MILITARY SPECIFICATION

GAGE ASSEMBLIES, AIR PRESSURE, DIAL INDICATING CHUCK TYPE, SELF-CONTAINED

This amendment forms a part of Military Specification MIL-G-8348H, dated 15 October 1981, and is approved for use by the Department of the Air Force and is available for use by all Departments and Agencies of the Department of Defense.

FIGURE 2. Class A gage assemblies

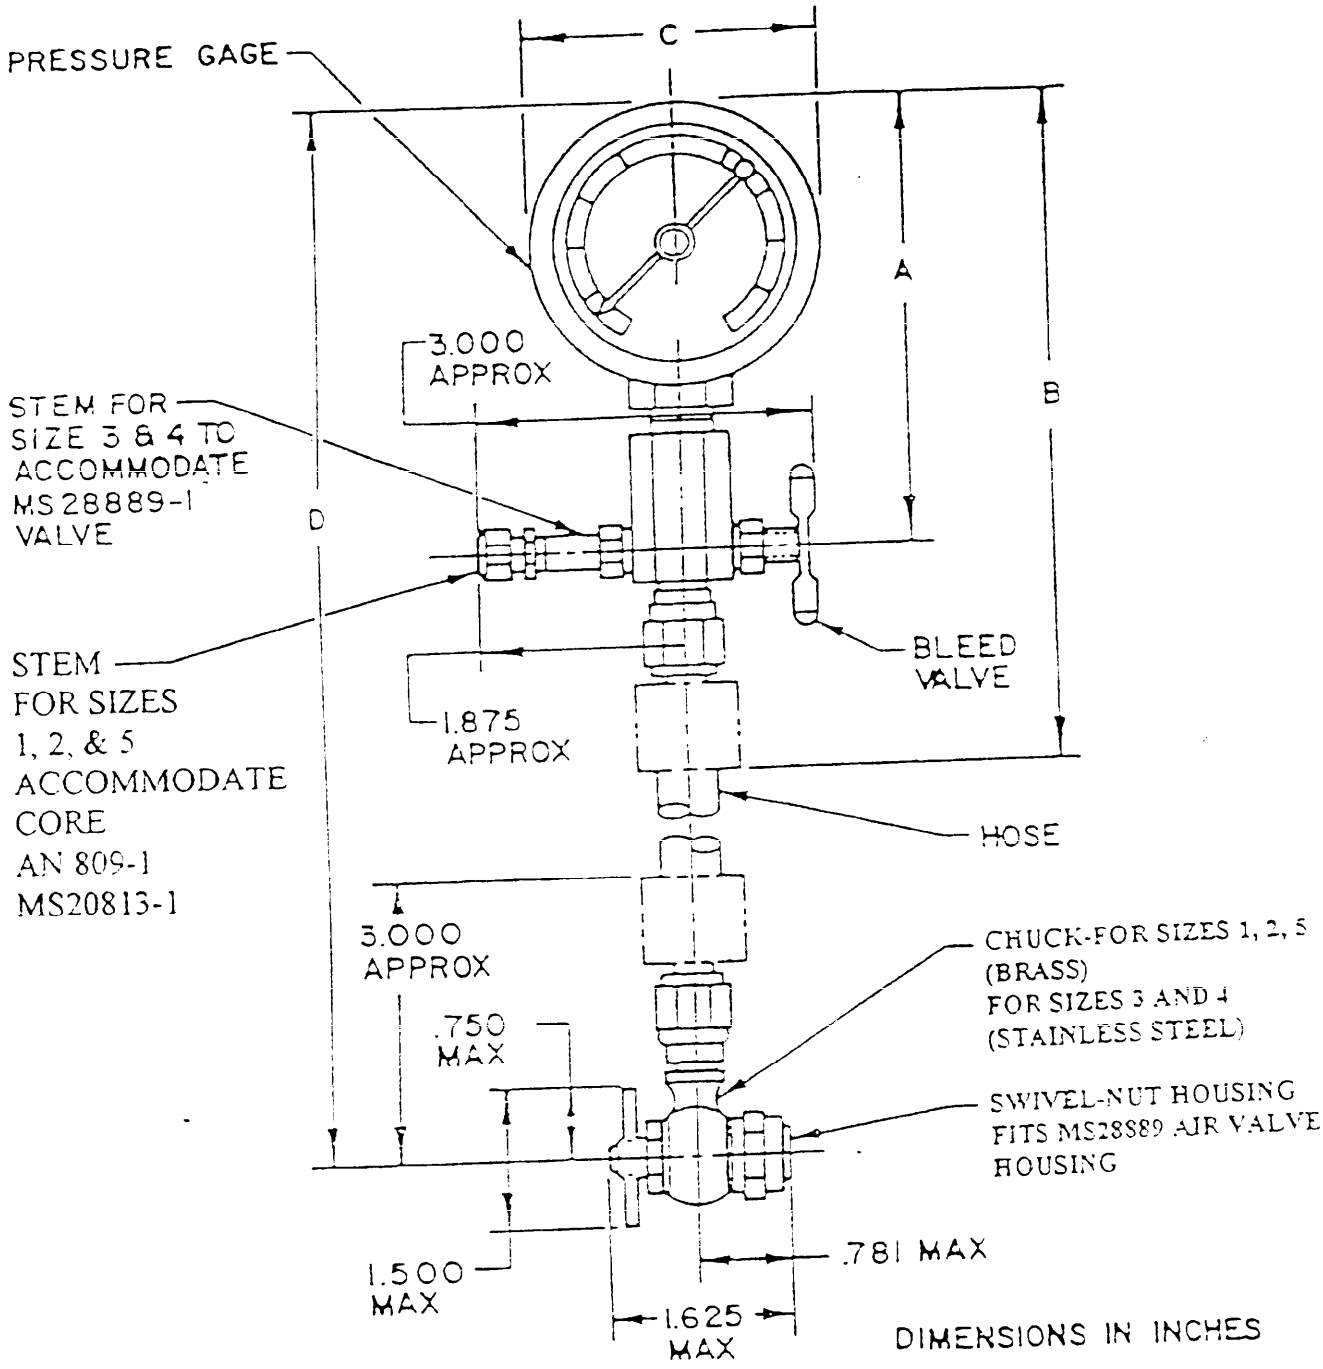
Delete FIGURE 2 and substitute with new FIGURE 2.
